File Number	PL 20-05	58	Contact		Kyle Deming, <u>kdeming@duluthmn.gov</u>	
Туре	Final Plat		Planning Commission Date		sion Date	June 9, 2020
Deadline	Application Date		May 15, 202	20 60 Days		July 14, 2020
for Action	Date Extension Letter Mailed		June 1, 202	0	120 Days	September 12, 2020
Location of Subject Upper side of 3700-3800 Blocks of London Road (Condon Park)						
Applicant	TJS Cons	struction, LLC	Contact	Contact Ted Stocke		
Agent			Contact			
Legal Description See attached						
Site Visit Date		April 1, 2020	Sign Notice Date		N	A
Neighbor Letter Date		NA	Number of Letters Sent		s Sent N	A

Proposal

Re-plat of 18 existing lots (3.05 acres) into 26 lots to be developed with 13 twin homes (two unit structures that straddle a common lot line) located along a private access road parallel to London Road. A home owners association will manage the private road, parking, storm water treatment, and building exterior maintenance. **Staff recommends** approval, with conditions

London East 3700-3800 Block of Upper Side of London Rd. TJS Construction, LLC

OFFICIAL PLAT

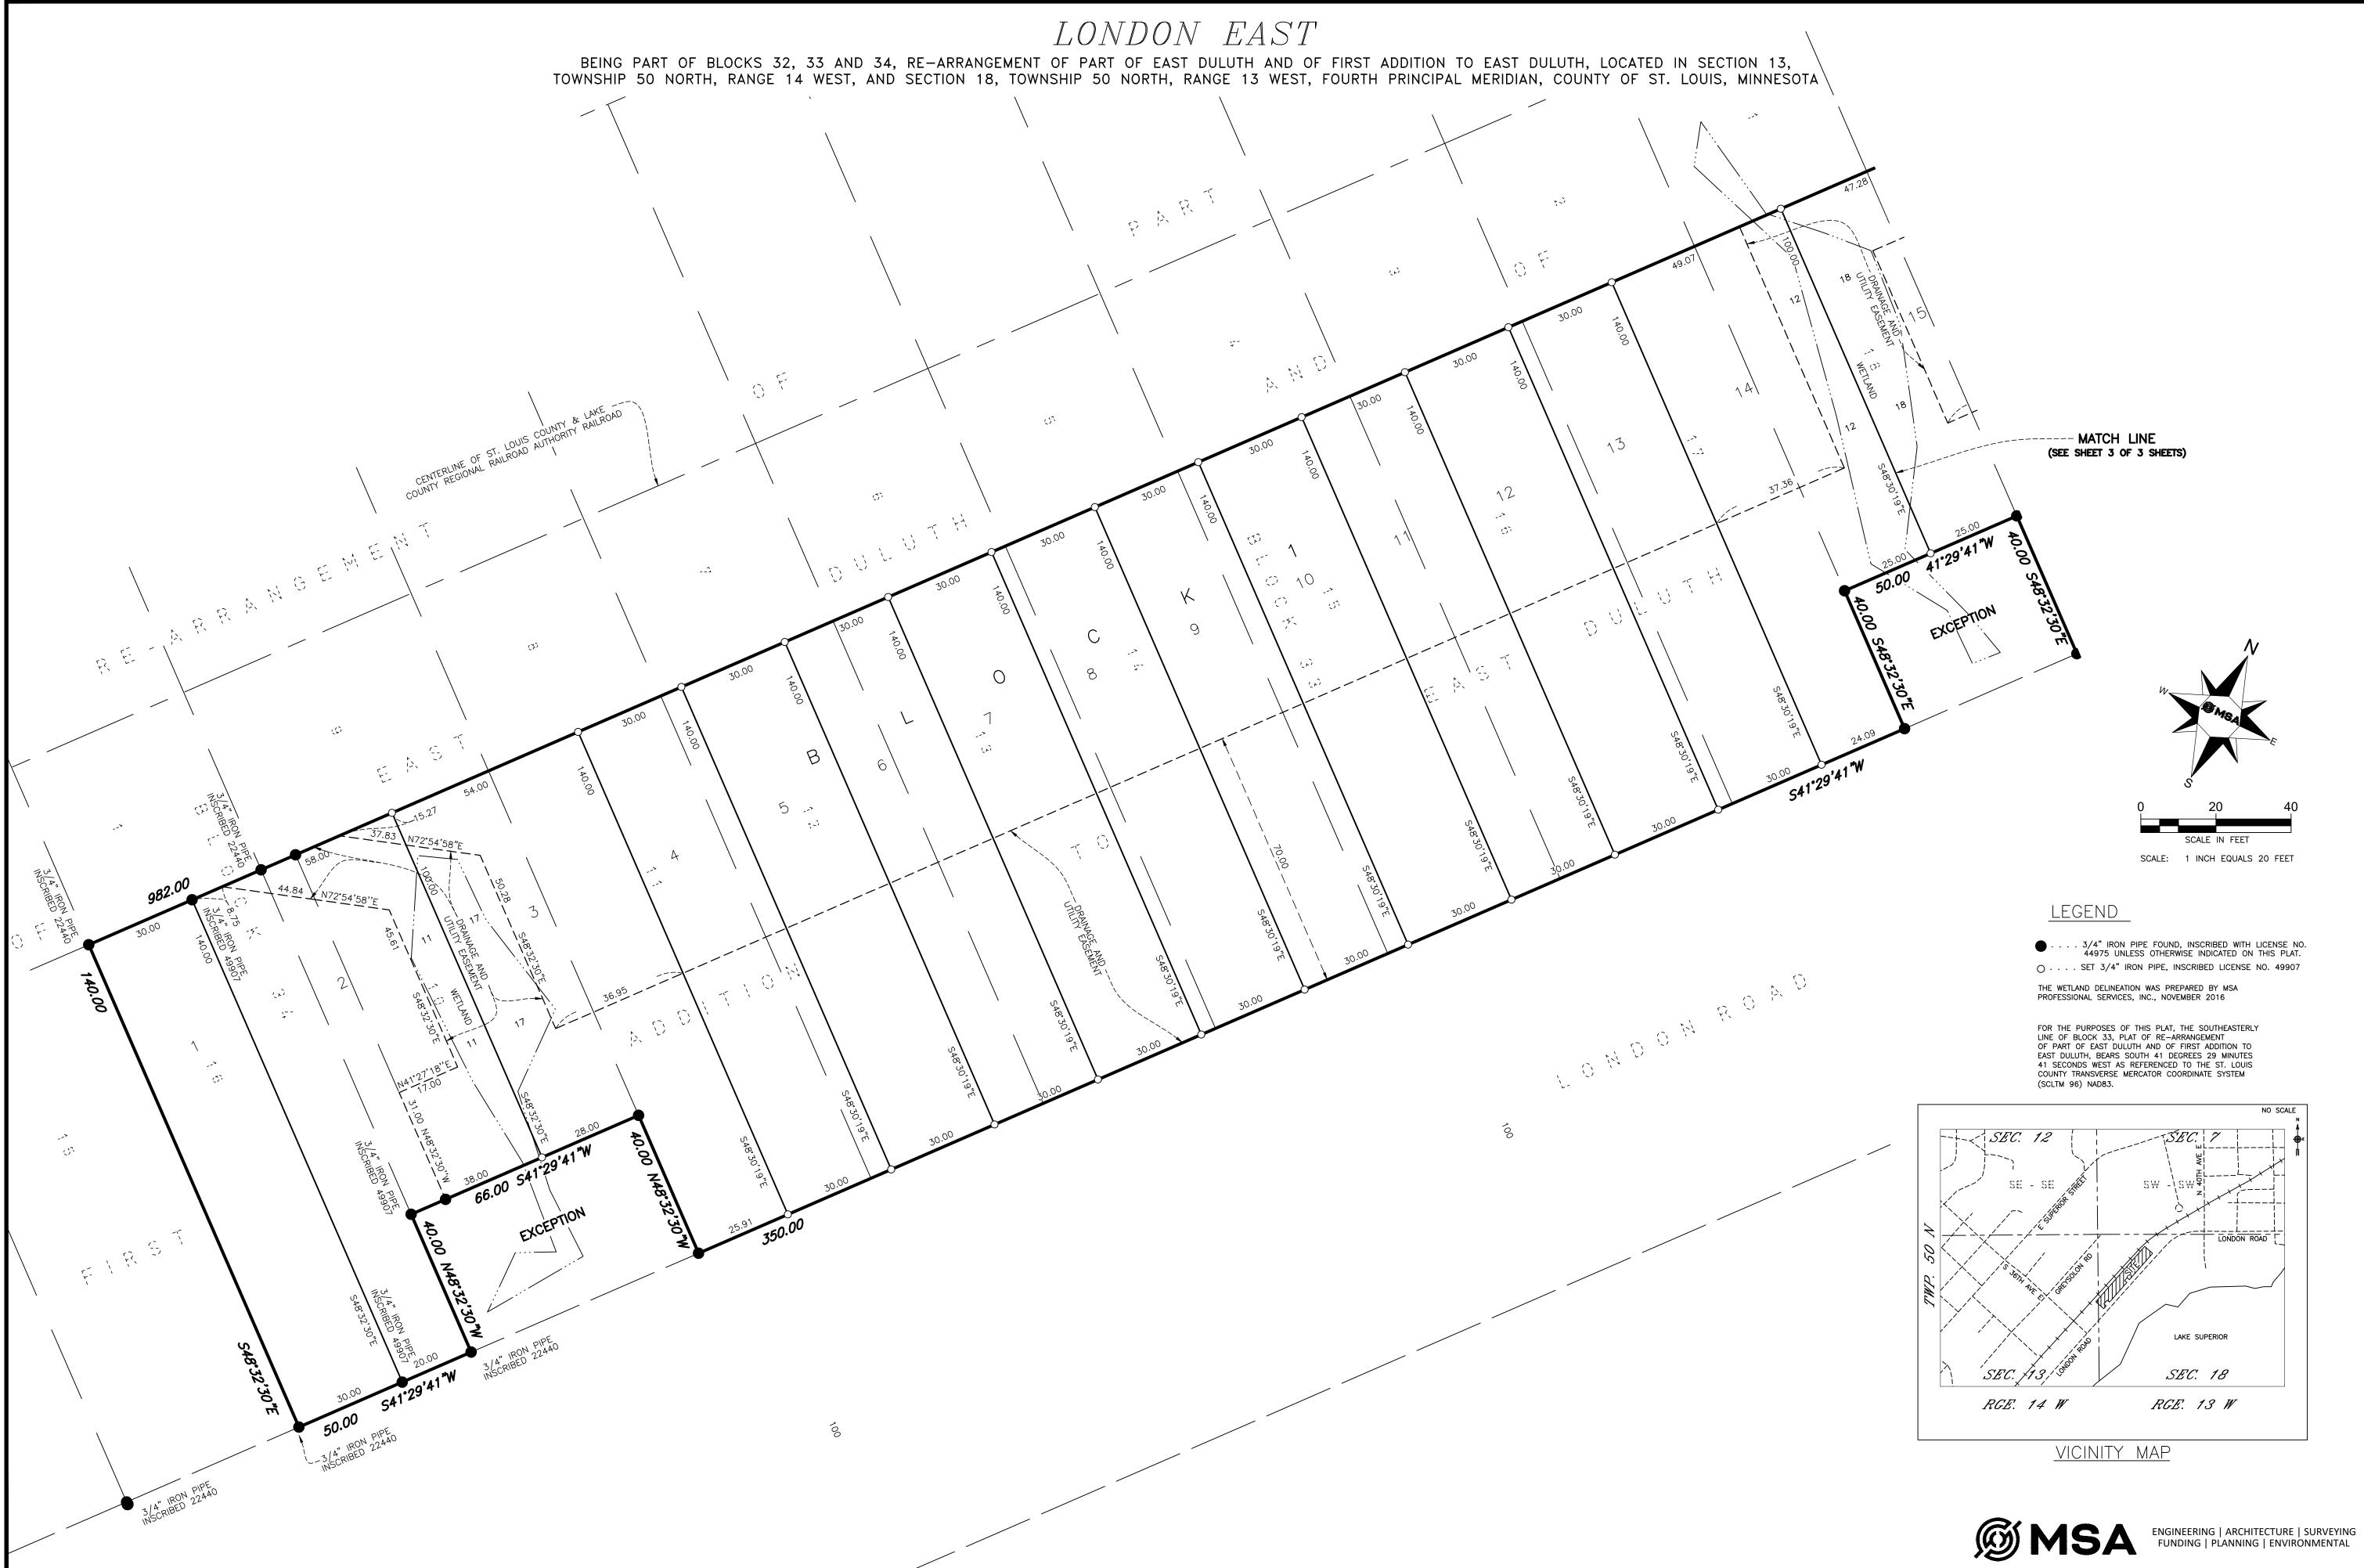
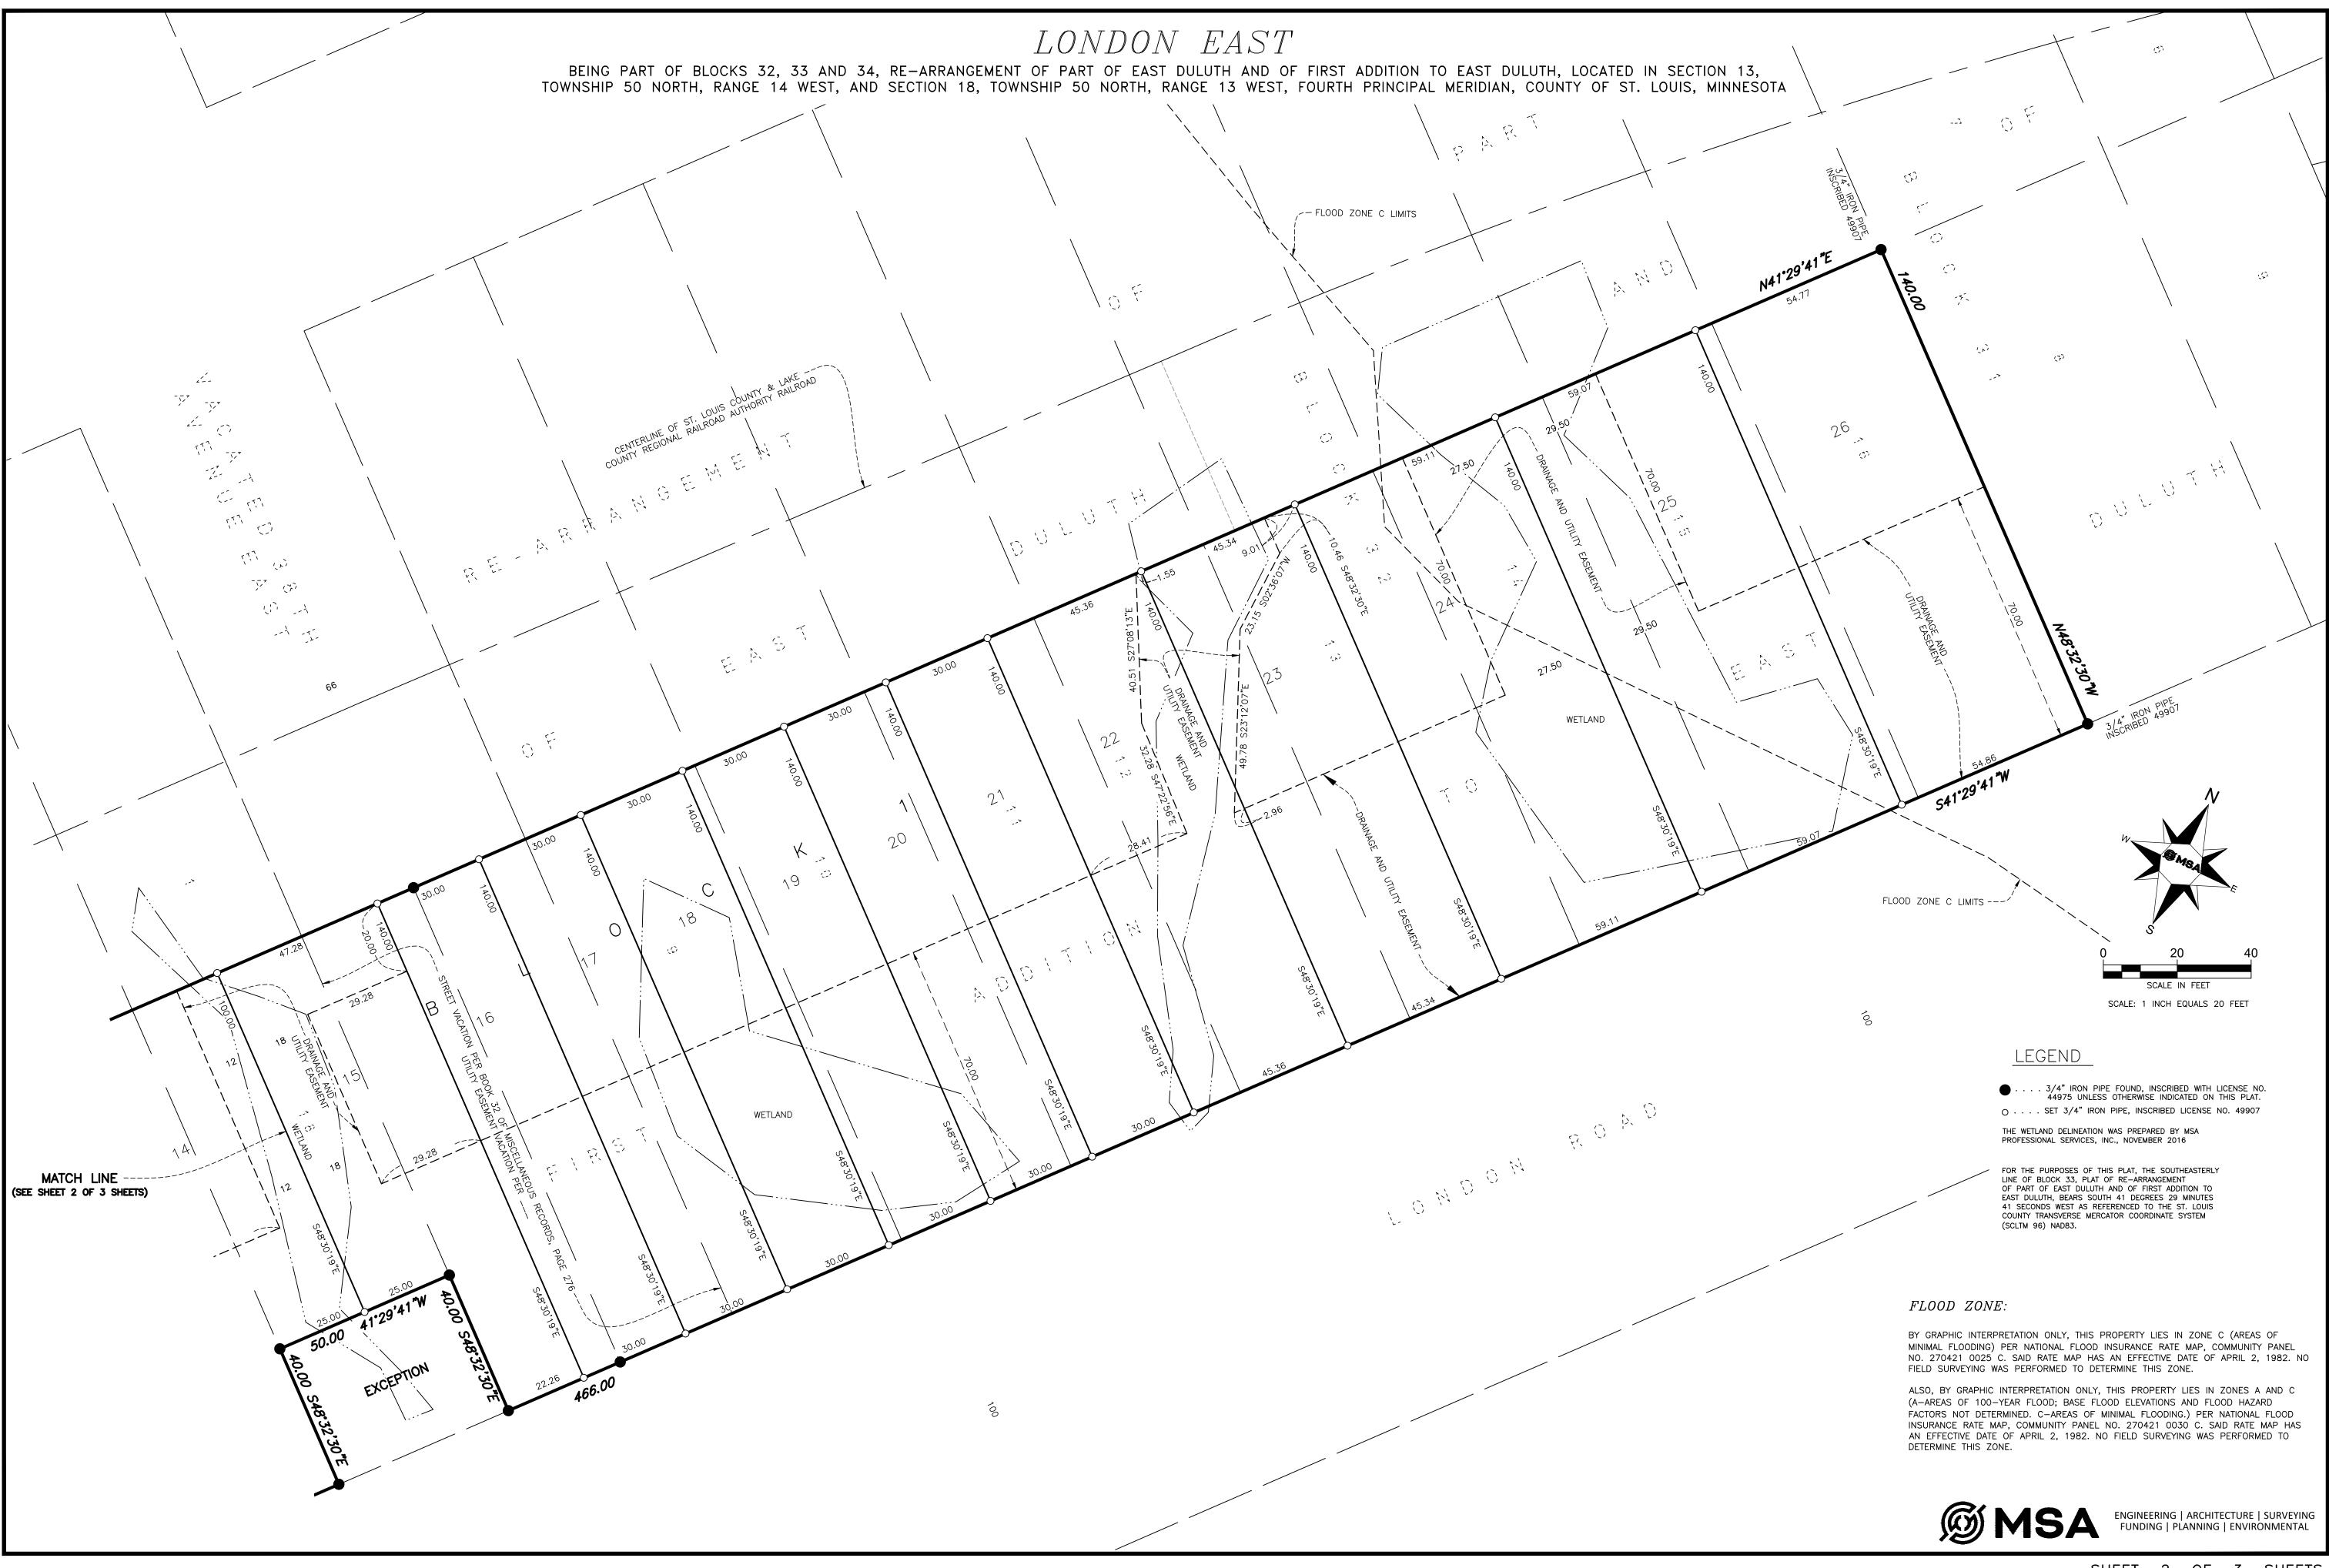
- a) The final plat be designed so that all of the lots are compliant with minimum lot area requirements. STAFF RESPONSE: Final plat has been revised to comply with lot standards.

- b) The utility easement on Lots 14 and 15 be extended eastward at the north plat boundary to connect to the existing utility easement in former 38th Avenue East. STAFF RESPONSE: Final Plat has been revised to include the utility easement extension.

1. The final plat be designed so that all of the lots are compliant with minimum lot area requirements.

This has been done.

2. The utility easement on Lots 14 and 15 be extended eastward at the north plat boundary to connect to the existing utility easement in former 38th Avenue East.

This has been done.

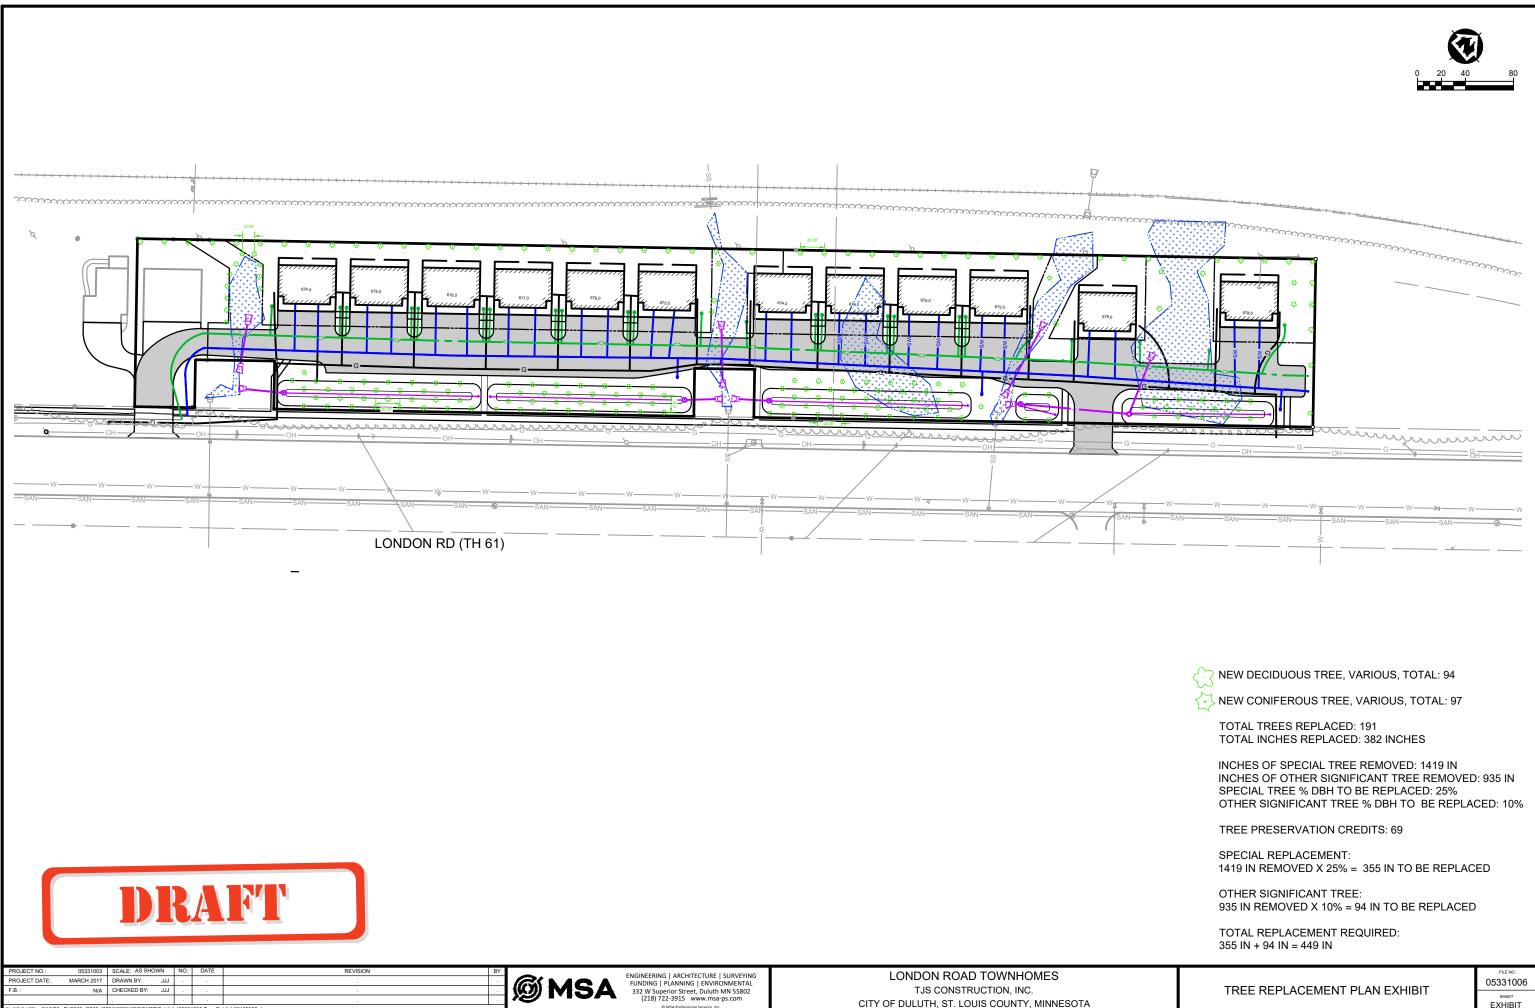
replacement plan and that trees to be preserved be protected with construction fence, including the area of the trees' dripline. STAFF RESPONSE: The applicant has submitted an updated tree preservation plan proposed removal of 2,354 caliper inches of trees and mitigating the impact, in part, through preserving 69 caliper inches of existing trees and the planting of 191 replacement trees as shown on the attached exhibit. Staff Response: Staff recommends that this continue to be a condition of the Final Plat.

10. Prior to tree removal activities, the applicant obtain from the Land Use Supervisor approval of a tree replacement plan and that trees to be preserved be protected with construction fence, including the area of the trees' dripline.

A draft plan has been prepared. This will be done after the plan is finalized.

RUCTION	EXHIBIT				
	1, 1111

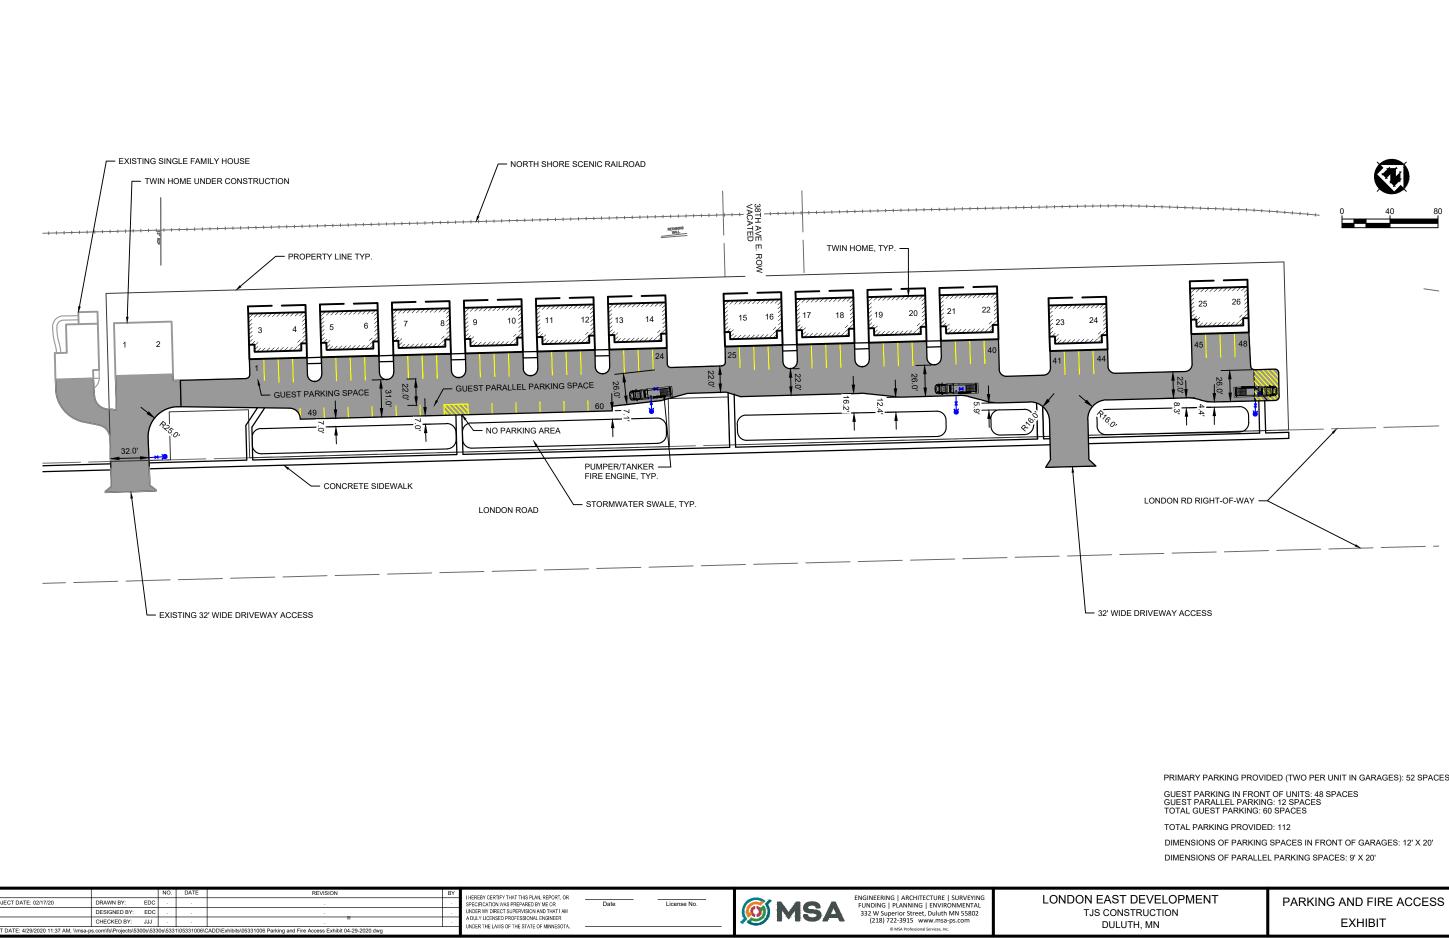
- f) Prior to issuing grading plans for the private access road, the Land Use Supervisor approve the location of guest parking throughout the site. STAFF RESPONSE: The applicant has provided an exhibit showing guest parking and staff recommends this continue to be a condition of the Final Plat.

12. Prior to issuing grading plans for the private access road, the Land Use Supervisor approve the location of guest parking throughout the site.

An exhibit has been prepared showing the guest parking locations. This will be done.
